RTCA Special Committee 209
ATCRBS / Mode S Transponder
Meeting #4

Summary of Issues Relating to the Figures
In the Draft of DO-181D

Gary Furr
L-3/Titan, FAA Technical Center

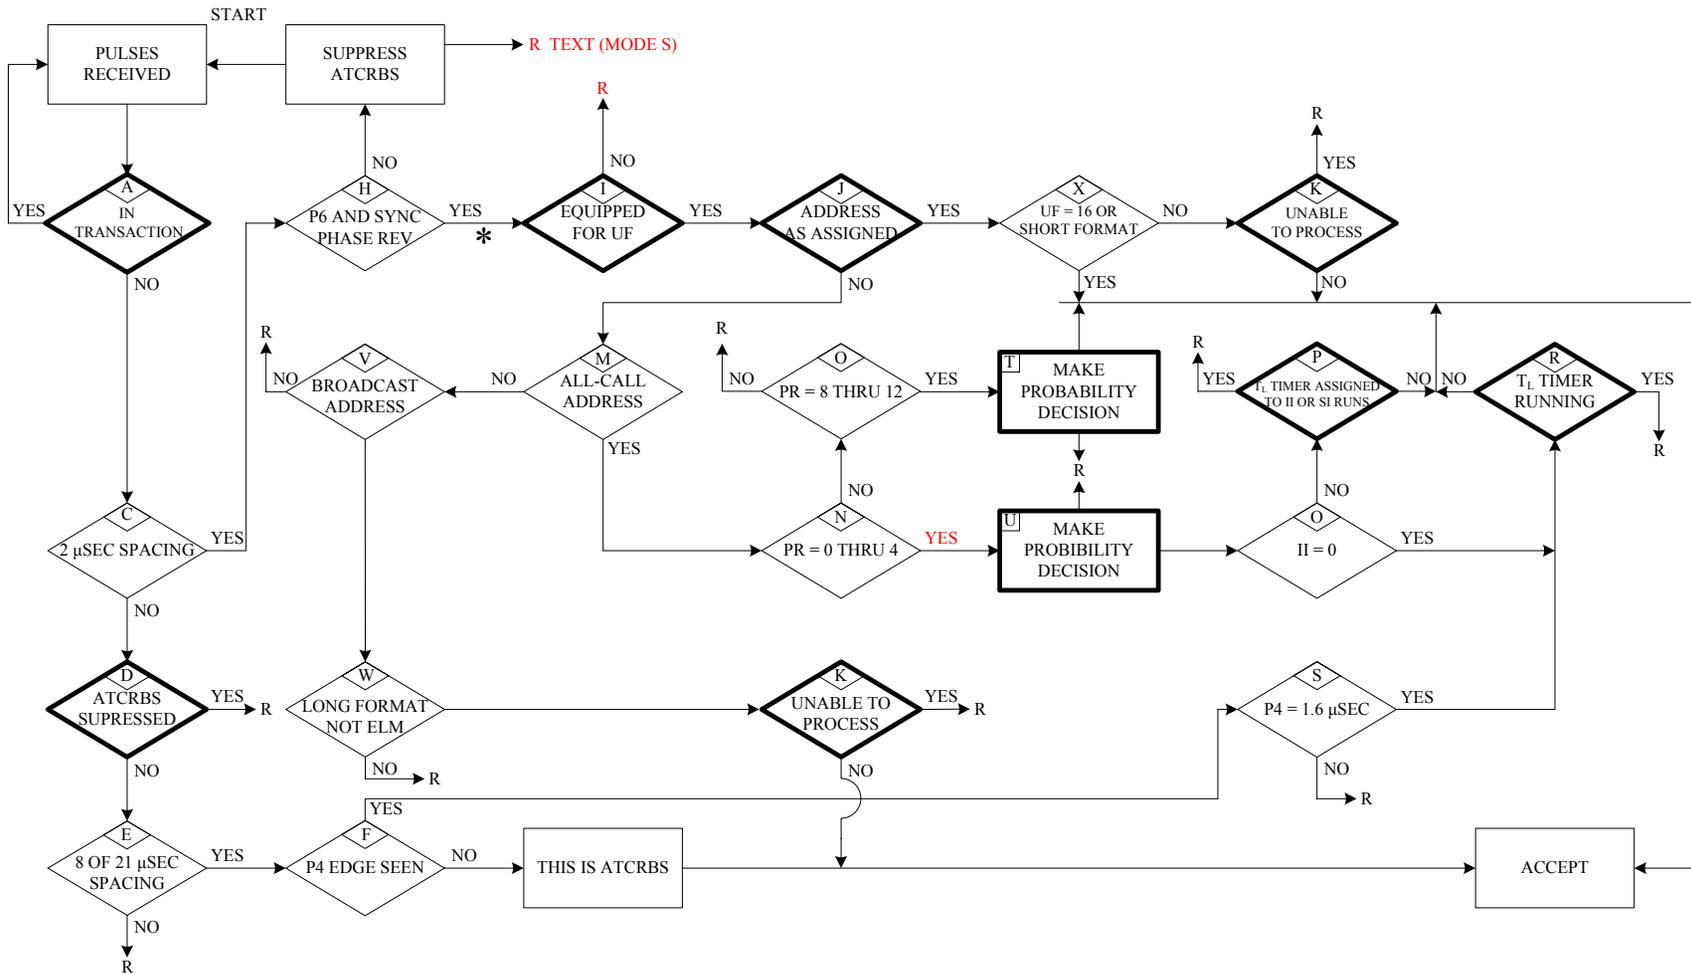
Figure 2-11	The "Suppress for ATCRBS" rectangle and the "I" diamond both point to "R Text (Mode S). (Ref page 225 in DO-181C)
	It appears a YES statement was missing from the original document to the right of diamond N. I think this should be added but need to confirm this. (Ref page 225 in DO-181C)
Figure 2-16	This is the same problem as in 2-11. The "Suppress for ATCRBS" rectangle and the "I" diamond both point to "R Text (Mode S). (Ref page 225 in DO-181C)
	This is the same problem as in 2-11. It appears a YES statement was missing from the original document to the right of diamond N. I think this should be added but need to confirm this. (Ref page 225 in DO-181C)
Figure 2-19	It appears a YES and NO statement is missing from the original document to the right and below diamond A. I think these should be added but need to confirm this. Of course the location of the Yes and No need to be verified also. (Ref page 234 in DO-181C)

Figure 2-16: Data Link Transponders Interrogation Acceptance

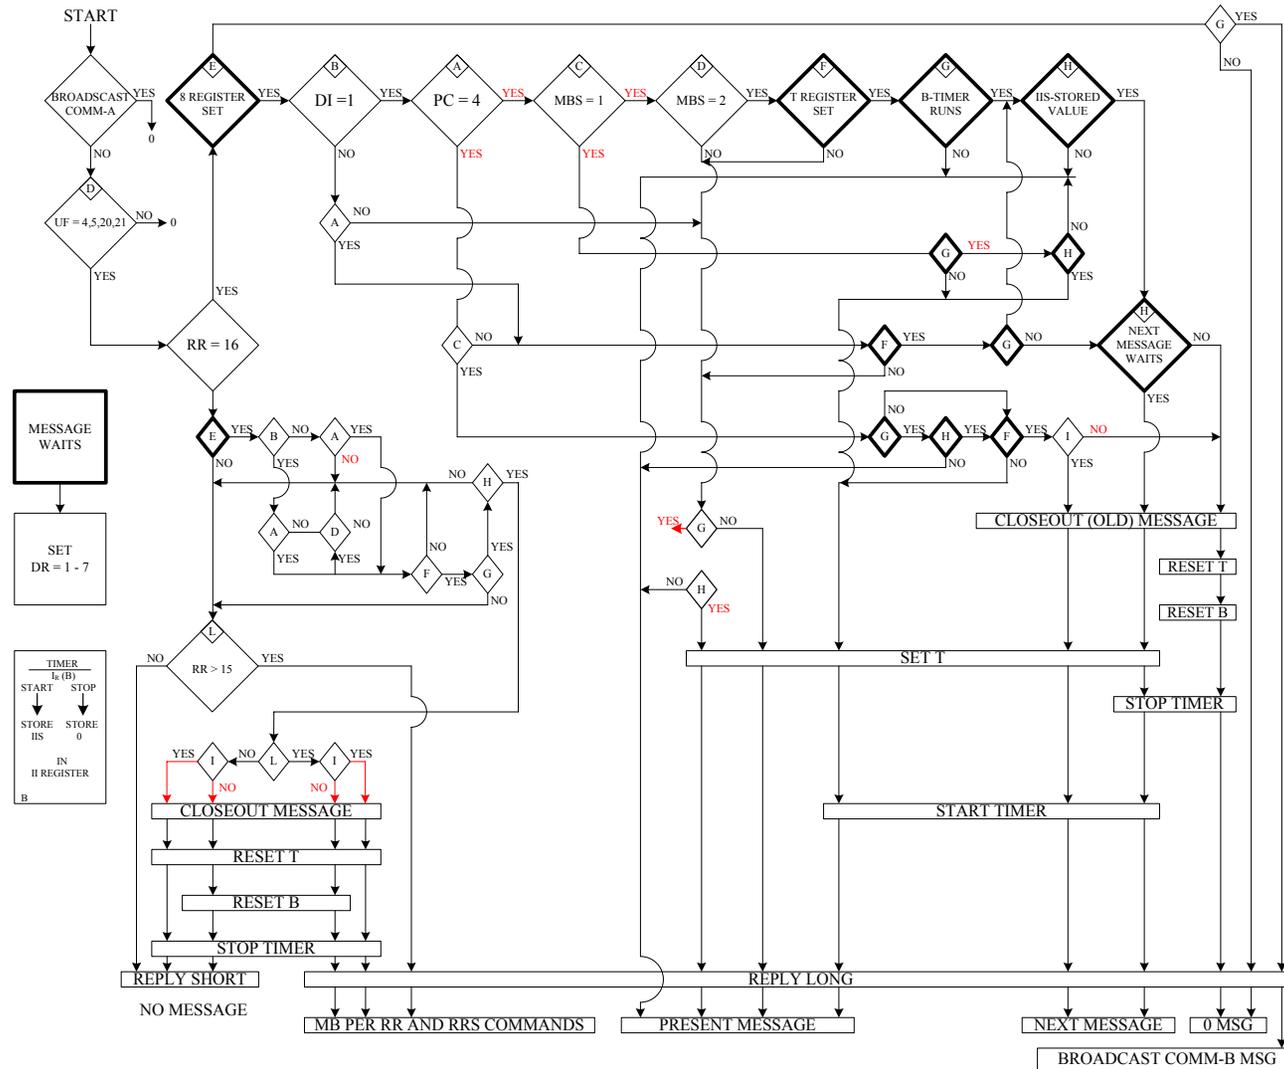
It appears a YES and NO statement is missing from the original document to the right and below diamond C. I think these should be added but need to confirm this. Of course the location of the Yes and No need to be verified also. (Ref page 234 in DO-181C)
	It appears a YES statement is missing from the original document to the right of diamond G. I think this should be added but need to confirm this. (Ref page 234 in DO-181C)
	It appears a NO statement is missing from the original document to below small diamond A. I think this should be added but need to confirm this. (Ref page 234 in DO-181C)
	It appears a NO statement is missing from the original document to the right of small diamond I. I think this should be added but need to confirm this. (Ref page 234 in DO-181C)
	It appears a YES statement is missing from the original document to the right of diamond G. ALSO, a line leaving small diamond G, with the YES should also be added going somewhere, either to the line to the left or just to the YES. I think this should be added but need to confirm this. (Ref page 234 in DO-181C)

Figure 2-19: All Data Link Transponders B Protocol

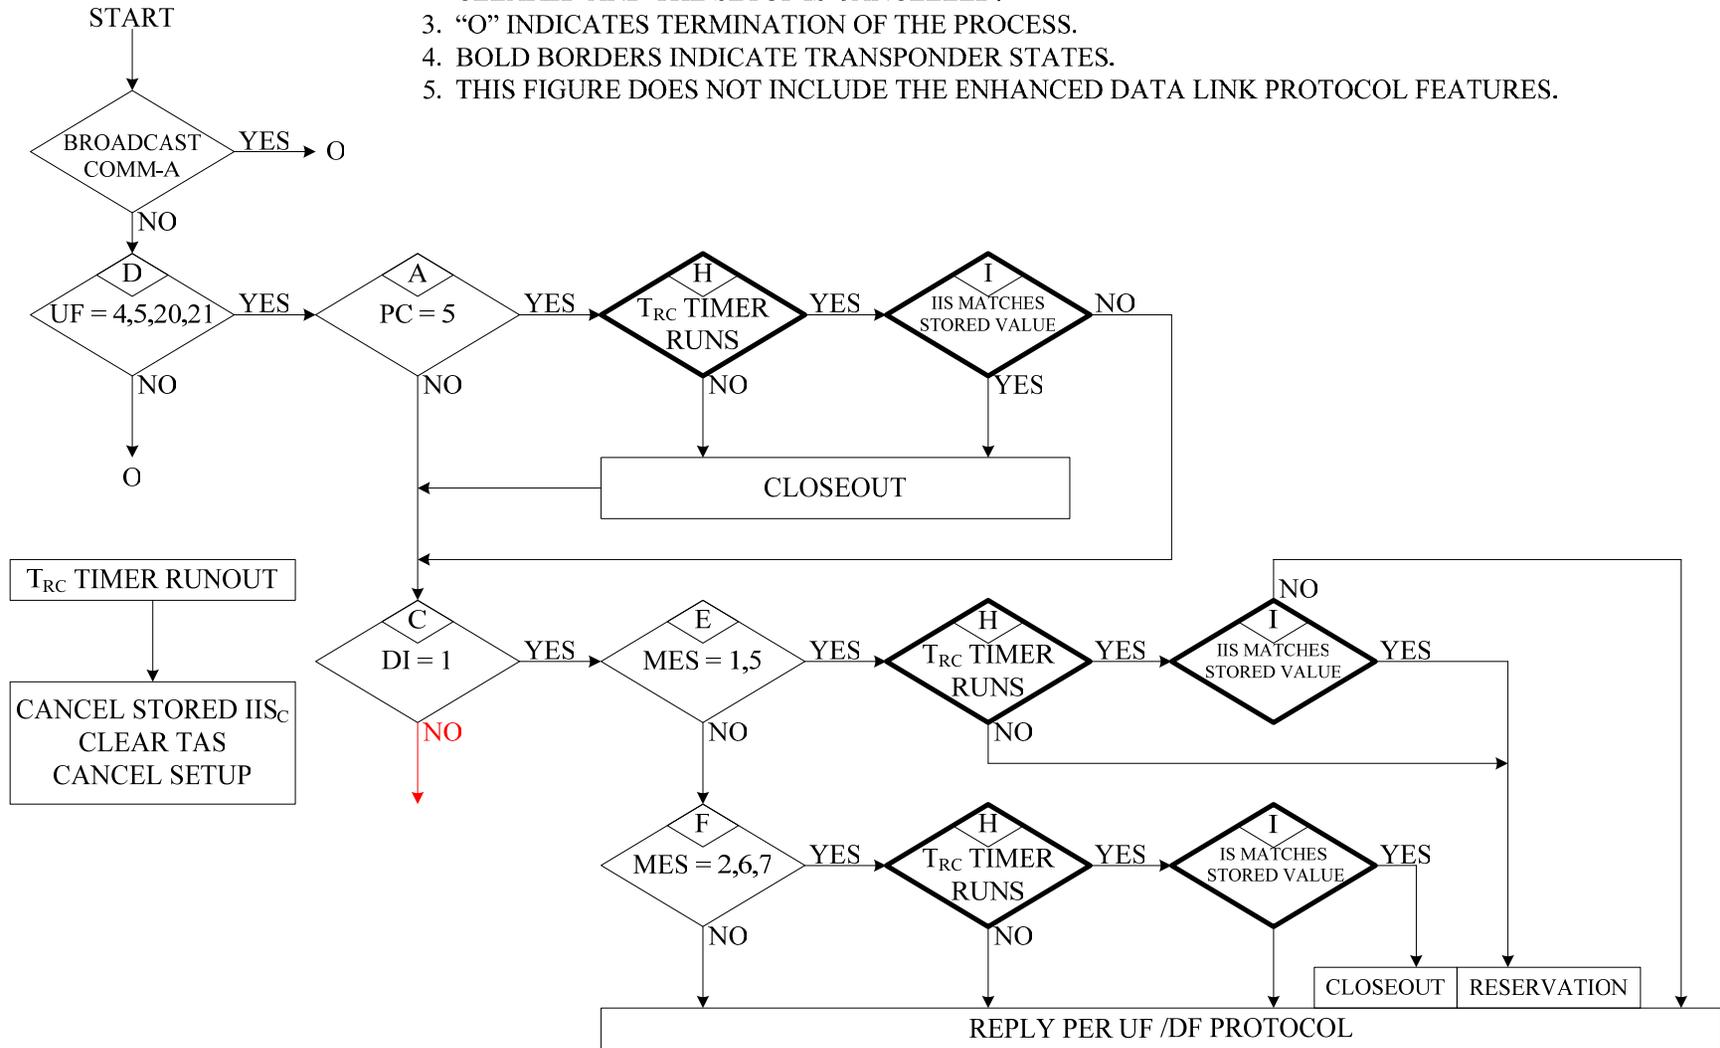
Figure 2-19	It appears a YES statement is missing from the original document below small diamond H. I think this should be added but need to confirm this. (Ref page 234 in DO-181C)
	It appears there may be a logic error in the lower left section of the diagram where an input goes to small diamond L. This may be right but just want to make sure. From L, if the answer is Yes or No you go to I (left or right). From I, if you answer Yes or No you go down to Closeout Message. Please verify this is correct. (Ref page 234 in DO-181C)
	Note 2 refers to "K". I cannot find this on this diagram. (Ref page 234 in DO-181C)
	Note 2 also states "DI≠7 OR DI=7" I can think of times when this logic makes sense but I can also think of times when this does not. Please verify this is correct. Leaving it as it is highlights the relationship this note has with '7'. The other argument goes something like this; 'If I have \$10 or if I don't go to the store.' That seems redundant to state. Again, this is probably correct just want to make sure. (Ref page 234 in DO-181C)

Note 7 refers to a para. This is worth noting since you will be rearranging the entire document and this reference will change. (Ref page 234 in DO-181C)
	Note 8, Is this correct, "DI=-" Please verify
Figure 2-20	Diamond C has a NO below it. It either needs a line going somewhere or it needs to be removed. (Ref page 235 in DO-181C)
Figure 2-22	Note 8 refers to a para please note this as you restructure the entire document. (Ref page 237 in DO-181C)
	In the lower left corner of the document, please confirm the item in red is indeed IIS _D . (Ref page 237 in DO-181C)
Figure 2-23	Note 2 refers to a para please note this as you restructure the entire document. (Ref page 238 in DO-181C)
	Please confirm the item in red is indeed IIS _D . (Ref page 238 in DO-181C)
